Re: **Master Plan – Supplemental Information**
Mt. Hope High School
199 Chestnut Street
Bristol, RI
(Pare Project No. 23099.01)

On behalf of the Bristol Warren Regional School District (BWRSD), Pare Corporation is pleased to submit the supplemental information requested by the Planning Board during the September 12, 2024 Planning Board Meeting. BWRSD seeks Master Plan approval for the Mt. Hope High School (Mt. Hope) project, which includes demolition of the existing building and the construction of a new high school. The supplemental information consists of the following:

On September 12, 2024 the Mt. Hope High School project was presented to the Planning Board. Please see the responses below to answer the questions raised during the Planning Board Meeting.

C3.0

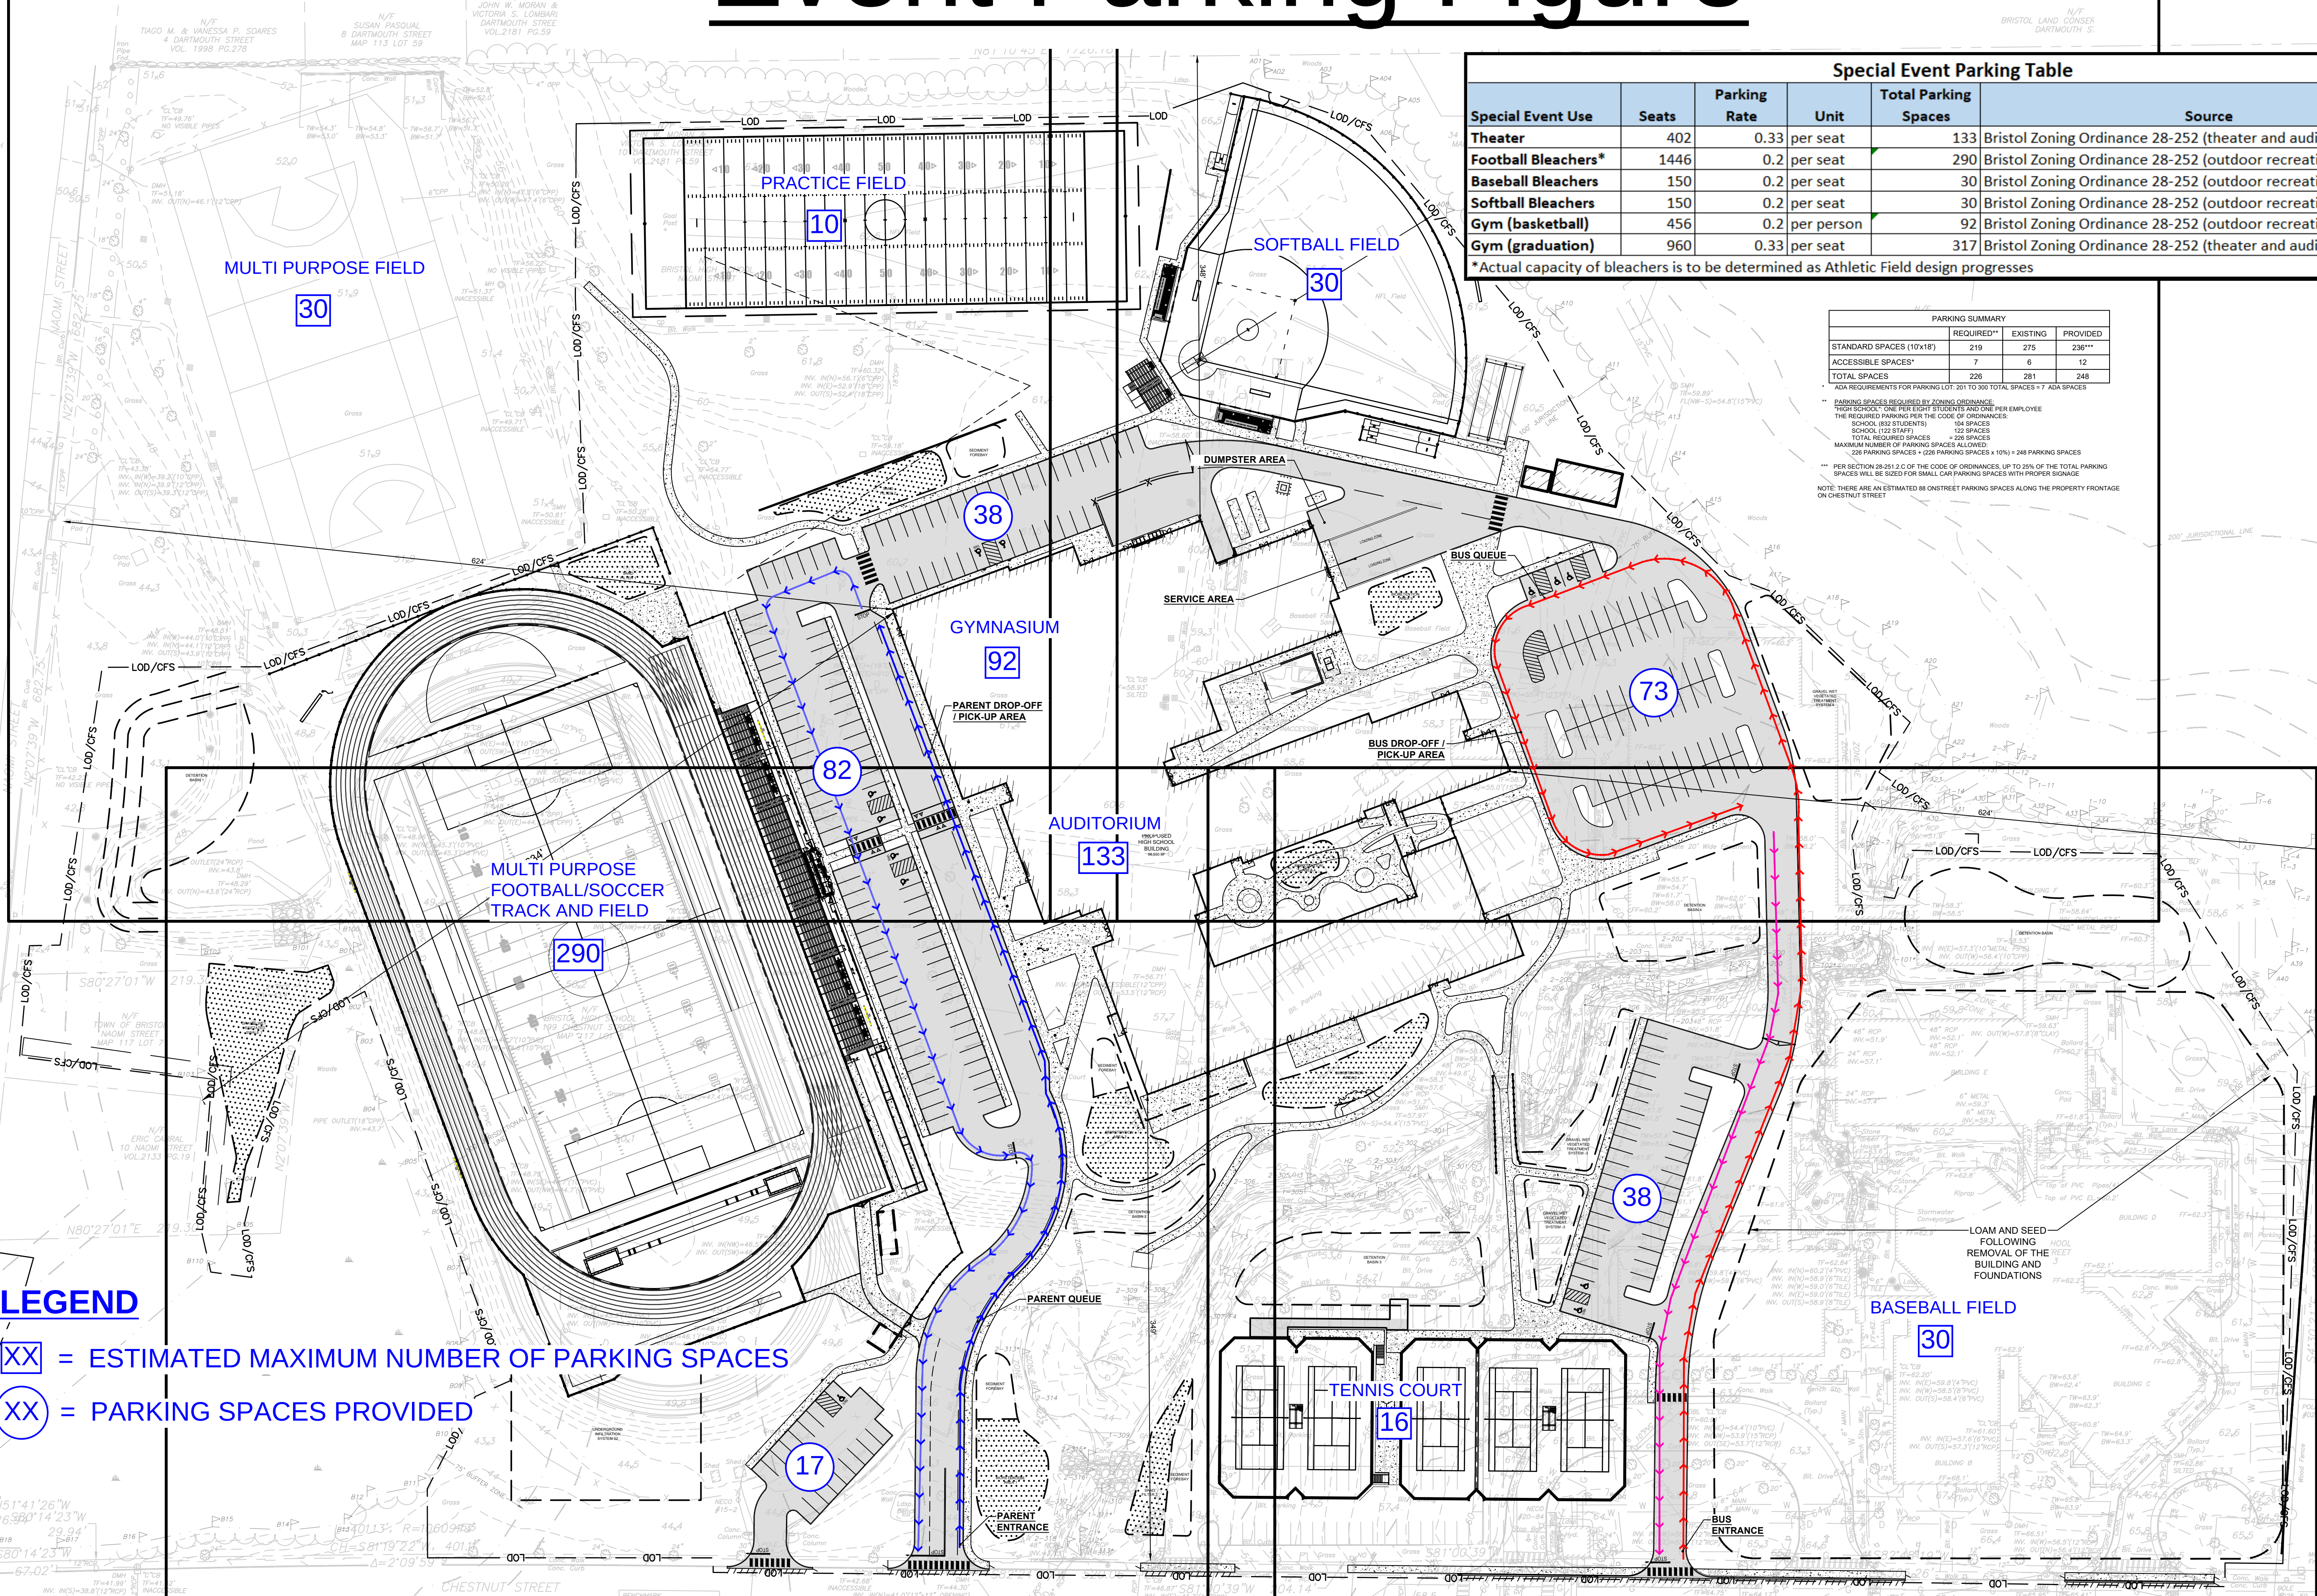
In response to concerns regarding the proposed 240 off-street parking spaces, the revised Master Plan Sheet C3.0 proposes 248 parking spaces. The existing high school has 281 parking spaces. BWRSD has determined that 248 parking spaces satisfies the future high school needs for the school day by providing parking spaces for the 122 staff members, 10 visitors and 116 students who are permitted to park on site. BWRSD anticipates the Master Plan will provide adequate parking spaces for the high school's operations and special events. Supplemental information to support the number of proposed parking spaces is included below:

- Attachment 2, presented in the Planning Board meeting on September 12, 2024, depicts the off-street parking available for the variety of anticipated athletic and cultural events.

- During events, additional parking is available on Chestnut Street and within a gravel lot at Paull Park. These two locations offer the public an additional 100 parking spaces.
